Model: SP3		Date: 15-Feb-98	No: 1
Modified Article: Bushing for Development		Prepared by: E.Fukuyama	
From: QAC Field Information Dept.			
Reason for Modification:	<input checked="" type="checkbox"/> Parts catalog correction <input type="checkbox"/> Vendor change <input type="checkbox"/> To meet standards <input type="checkbox"/> To facilitate assembly <input type="checkbox"/> To improve reliability    (    ) <input type="checkbox"/> Part standardization <input type="checkbox"/> Other

Model: SP3		Date: 15-Mar-98	No: 2									
Modified Article: Controller HDD		Prepared by: A.Tokoyama										
From: QAC Field Information Dept.												
Reason for Modification:

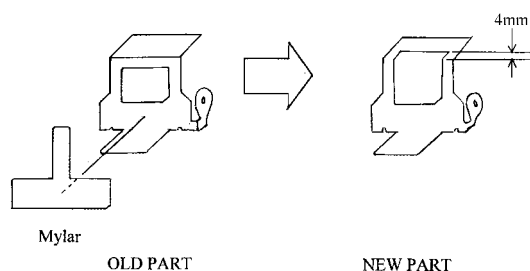
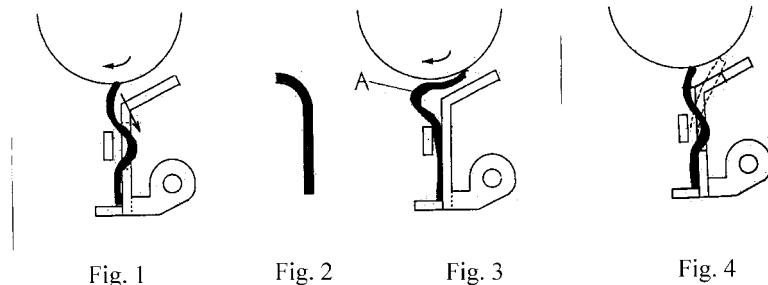
To improve the durability of the vibrating plate mylar in the duplex unit, the shape of the vibrating plate has been changed.

Mylar damage

The mylar should move as shown in Figure 1, but after repeated use of the 50-sheet stack mode in the duplex unit, the mylar may curl as shown in Figure 2. If the mylar becomes deformed as shown in Figure 2, then its movement will resemble that shown in Figure 3. If this movement is repeated, then section A of the mylar will be damaged.

To prevent the mylar from curling, the shape of the bracket has been changed so that the mylar will bend as shown in Figure 4 below.

Old part number	New part Number	Description	Qty	Int	Page	Index	Note
A1544623	A1544626	Vibrating Plate	2	1	65	26

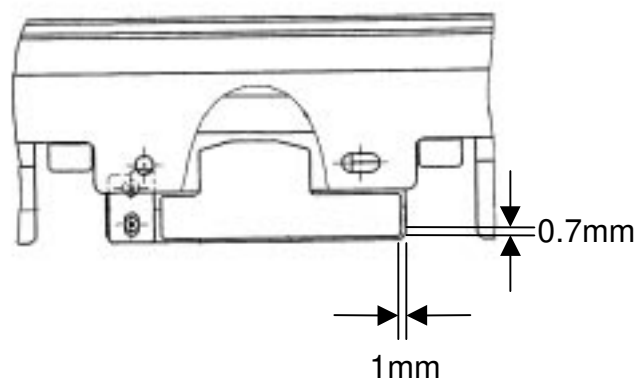
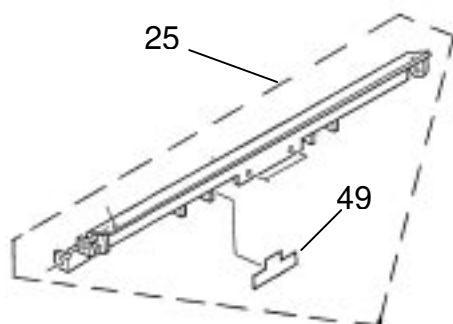
Please add the following part to the parts catalog.

Please refer to the illustration below for the attachment position of the mylar.

Old part number	New part number	Description	Qty	Int	Page	Index	Note
	A1344670	Duplex Guide Mylar	1		65	49	New Index

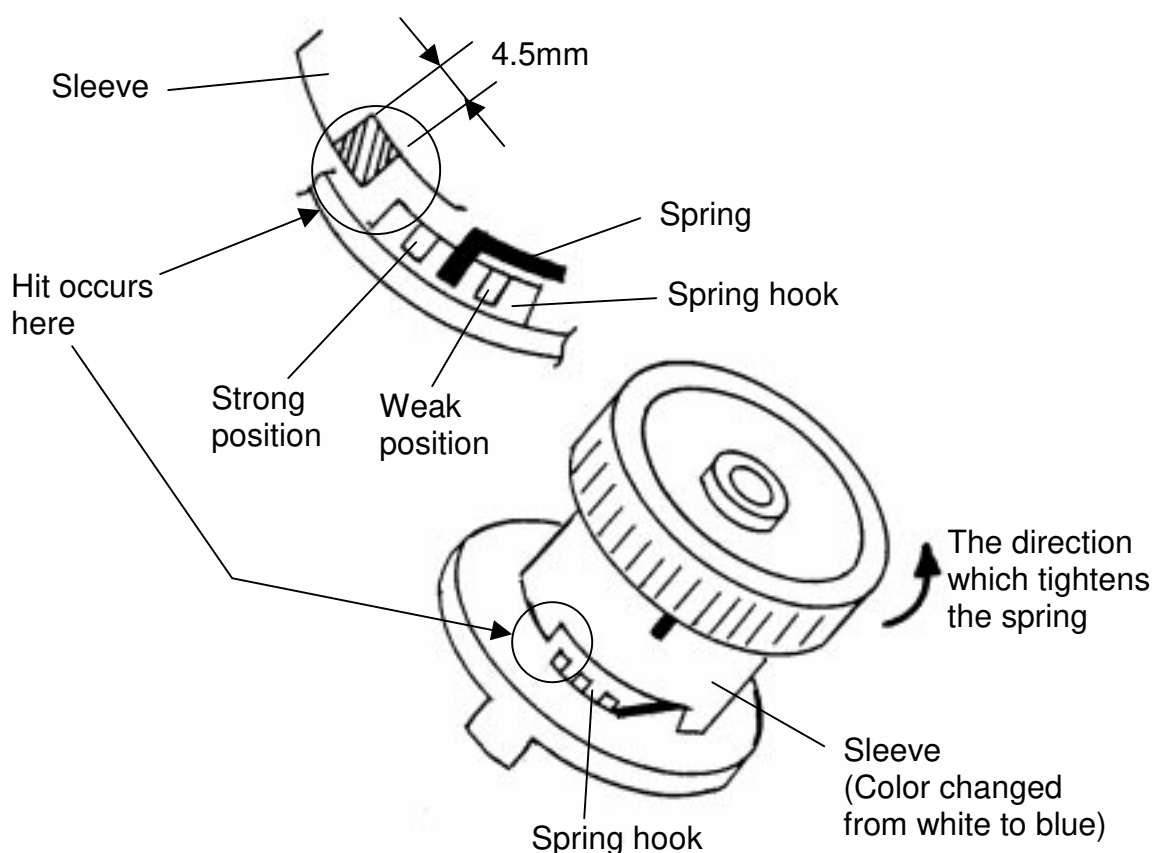
To reduce no-feed jams in the duplex unit caused by insufficient pressure from the bottom plate, the shape of the spring clutch has been changed. To distinguish between the old and new clutches, the color of the sleeve has been changed from white to blue.

The insufficient pressure occurs when the clutch turns in the direction which tightens the spring. This is because when the sleeve hits the spring hook, the spring cannot turn completely, so the bottom plate cannot be lifted up to the highest position.

To prevent the sleeve from hitting the spring hook, a 4.5-mm wide section of the sleeve has been cut away as shown.

Old part number	New part number	Description	Qty	Int	Page	Index	Note
AB040015	AB040017	Spring Clutch – Tray Bottom Plate	1	X/O	65	35

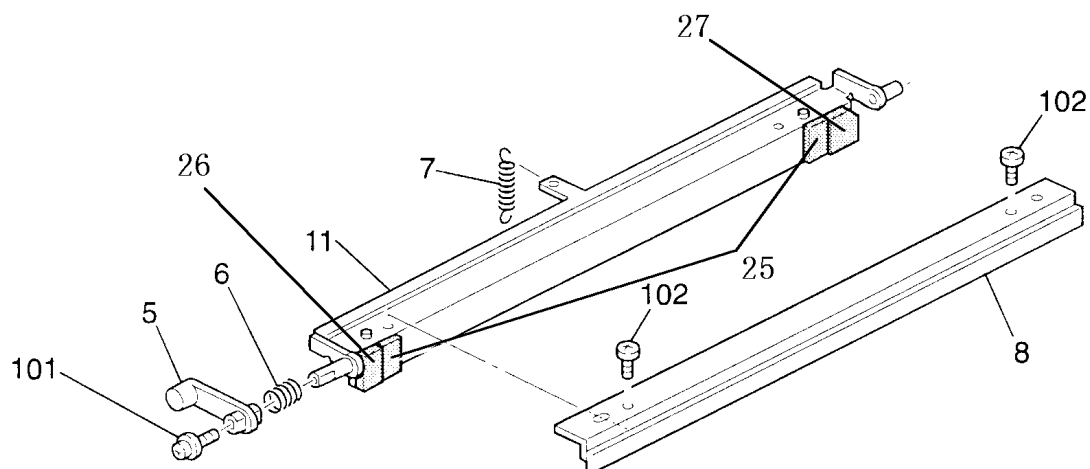
The following parts have been added as service parts.

Please add them to your parts catalog.

Old part Number	New part Number	Description	Qty	Int	Page	Index	Note
	AA151809	Rear Seal	2		51	25	New Index
	AA151807	Shield:Blade:Front	1		51	26	New Index
	AA151782	Shield:Blade:Rear	1		51	27	New Index

## 5. TRAY PAPER FEED (A195)

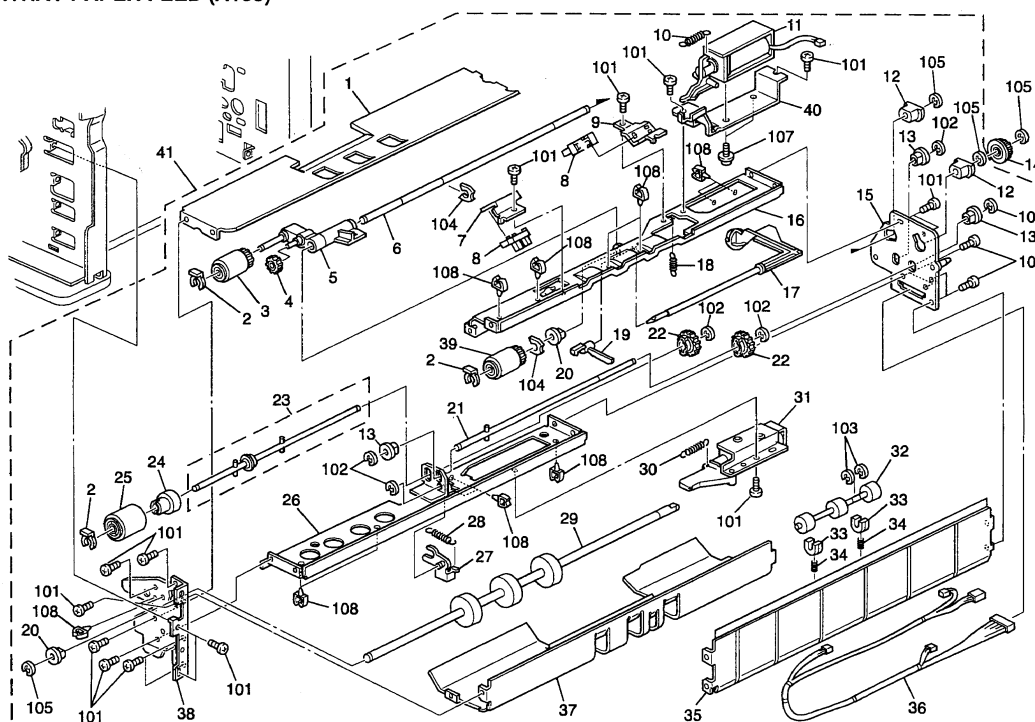
The following parts have been added. Please correct your parts catalog.

Old part number	New part number	Description	Q'ty	Int	Page	Index	Note
	A13427250	Paper Feed Unit – Lower	1		19	41

## 1.EXTERIOR (A195)

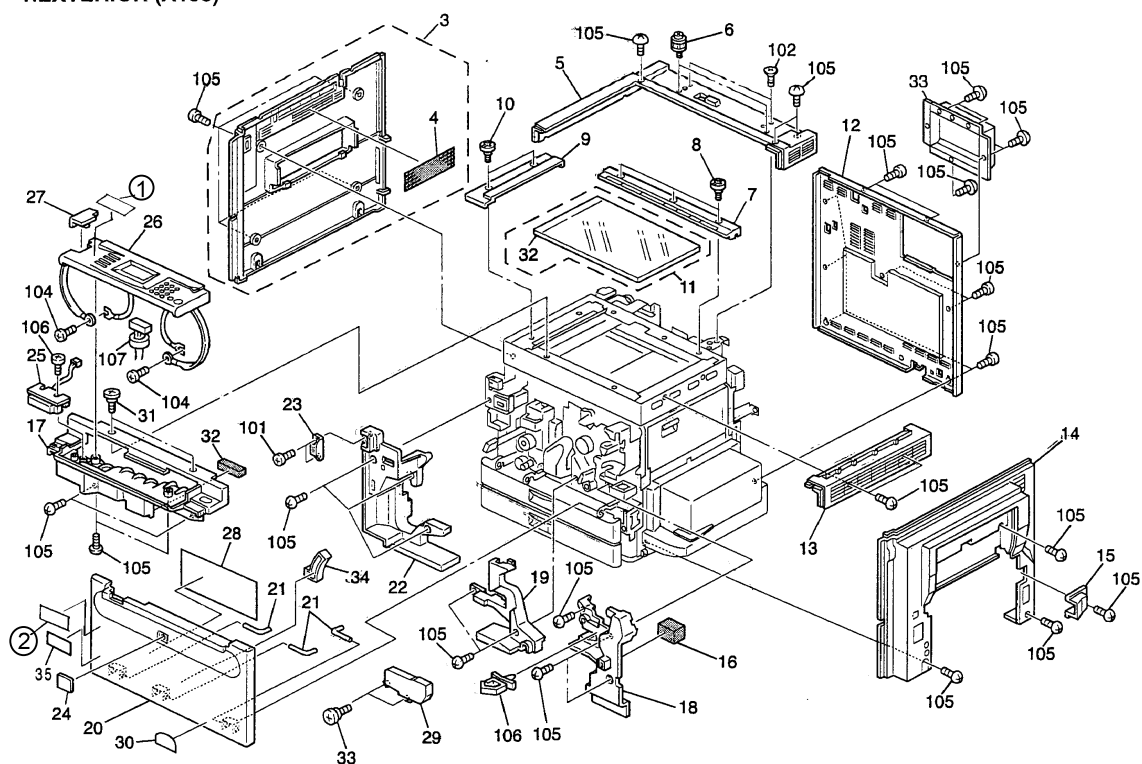
The Copy Tray Slide (index no.1), Copy Tray Guide (index no.2) and Copy Tray (index no. 30) should be deleted from the illustration on page 10.  
 Index number 30 listed on page 11 refers to the energy star decal. Index numbers 1 and 2 both refer to the decals that were not included in the original illustration.  
 Please adjust your illustrations accordingly as shown below.

## 14.OPTICS SECTION 2 (A195)

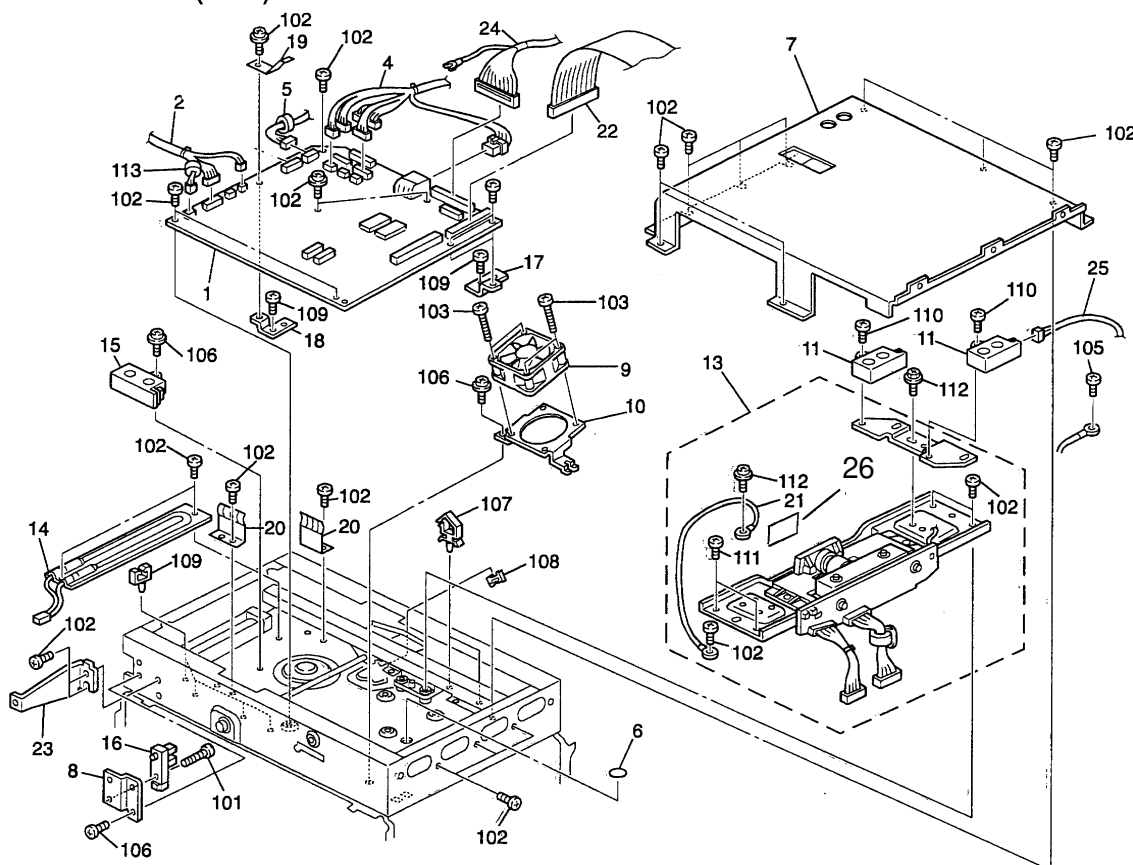
The following part has been added as a service part.  
Please add this to your parts catalog.

Old part number	New part number	Description	Q'ty	Int	Page	Index	Note
-	AA011041	Light Filter-G530/G533	1	-	37	26
